CCB 8030.008

Pre and Post Change Summary

PCN #: MFOL-15LJZP349

Pre and Post Change Summary – Tube (PDIP)

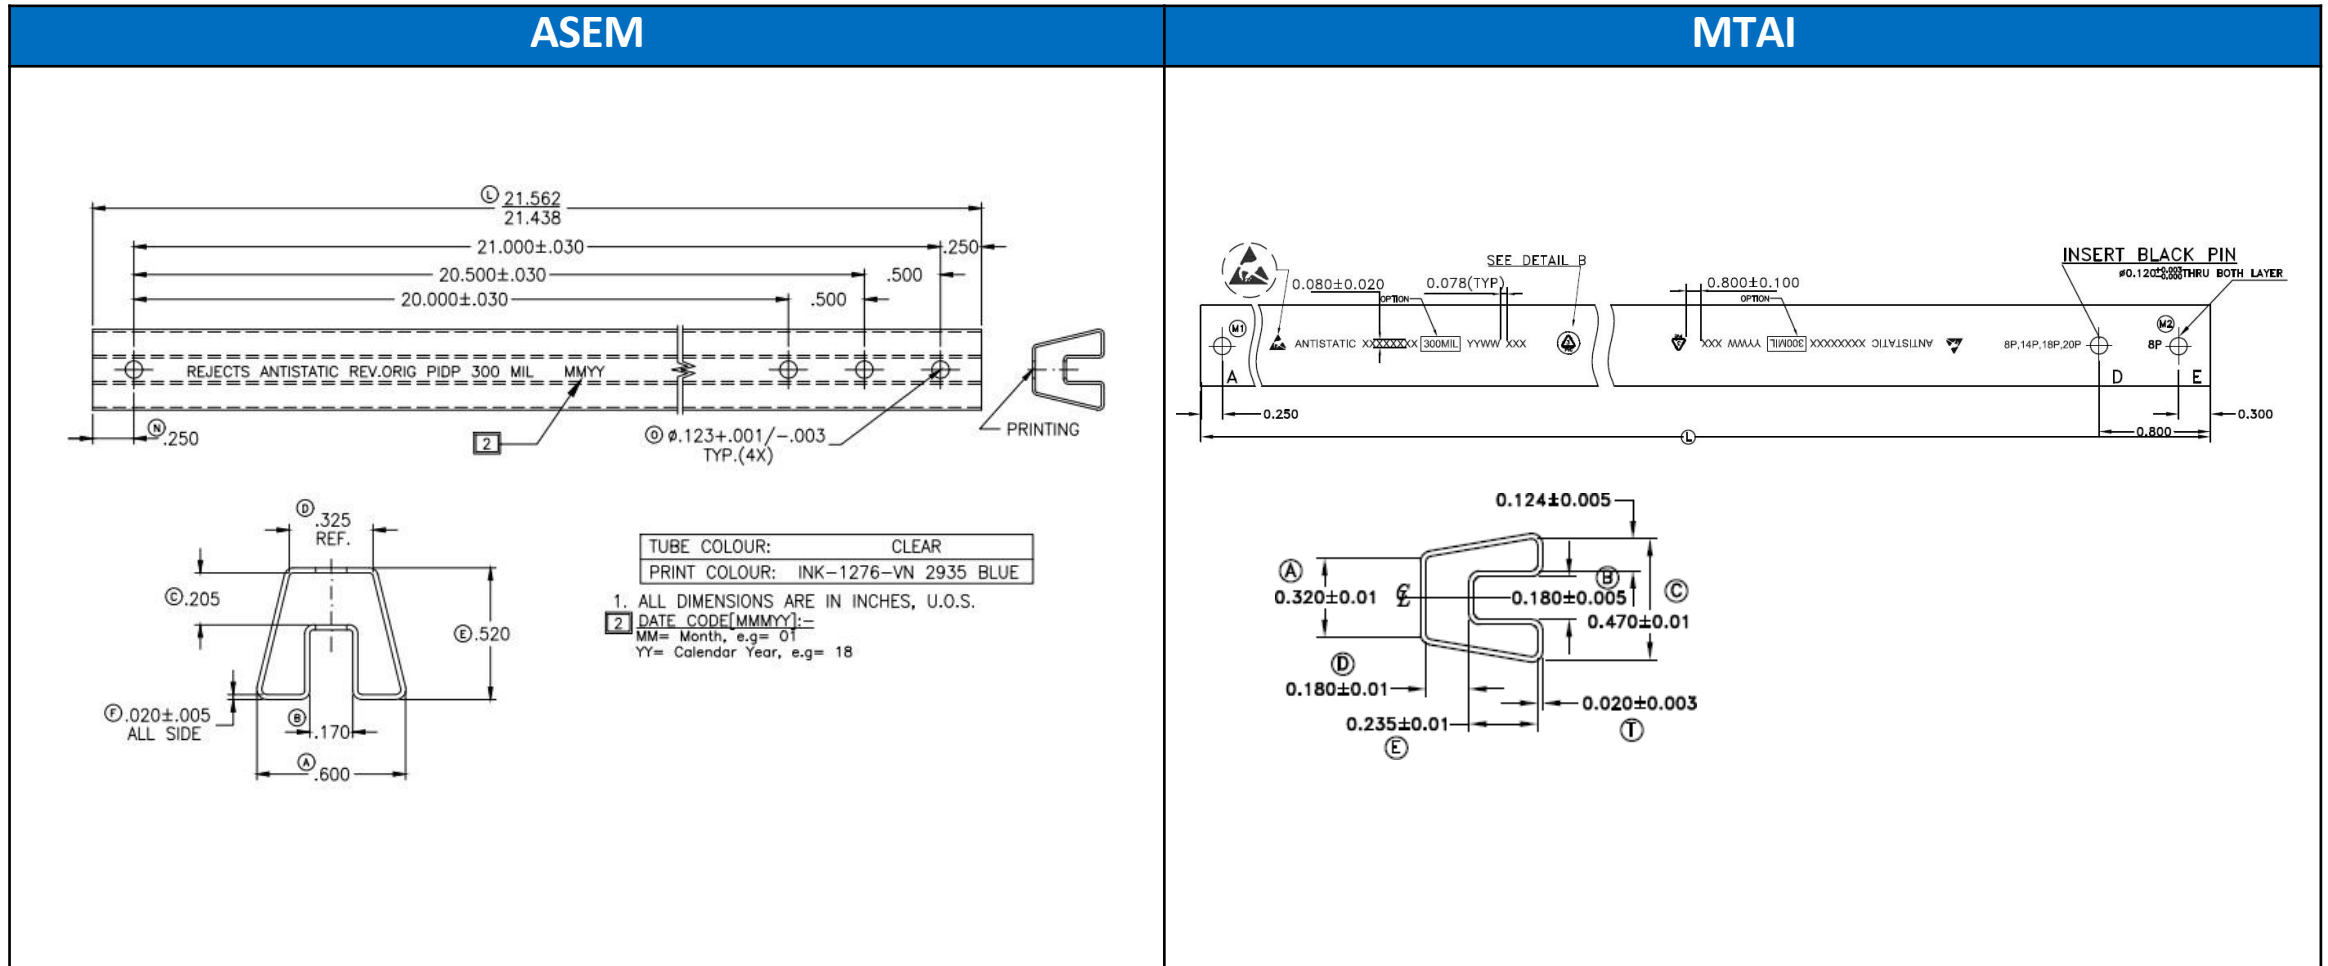
Plant	Tube Length (inch)	Hole Usage	Tube Length between Hole Usage(inch)	Tube Color	Unit per Tube	Tubes per Bag
ASEM	21.562±0.10	1	21.000±0.30	Clear	25	25
MTAI	20.33 ±0.030	Hole A to Hole E	19.28 ±0.030	Clear	25	60

Pre and Post Change Summary – Tube Pin Color (PDIP)

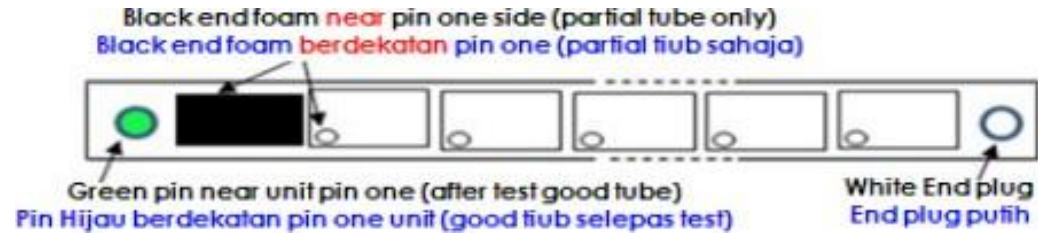
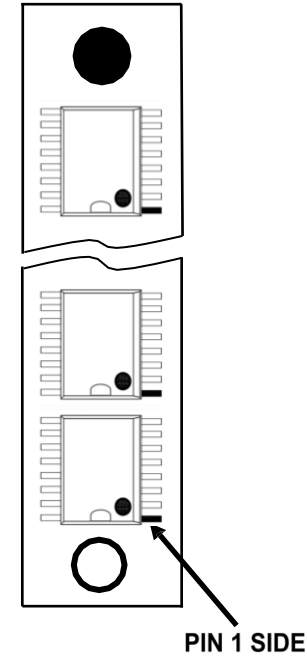
Media	Pin Side Color	Opposite Side Color
Pin	Green	White

Media	Pin Side Color	Opposite Side Color
Pin	White	Black

Pre and Post Change Summary – Tube Bag (PDIP)

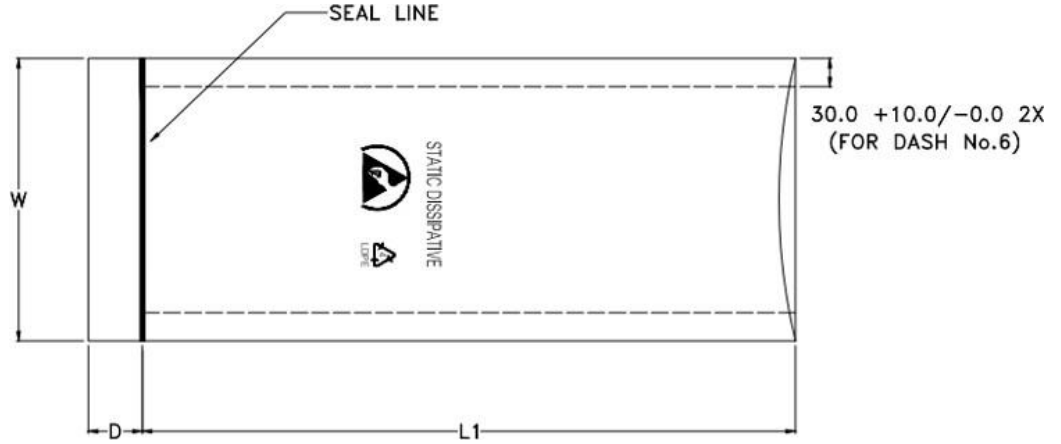
Plant	Bag type	Length (mm)	Width (mm)	Thickness (mm)
ASEM	Static Shielding Bag	635.00±5.00	230.00 ±5.00	0.0762
MTAI	Antistatic Pink Gusset	760 +10/-5	140 +10/-0	0.100 +/- 0.01
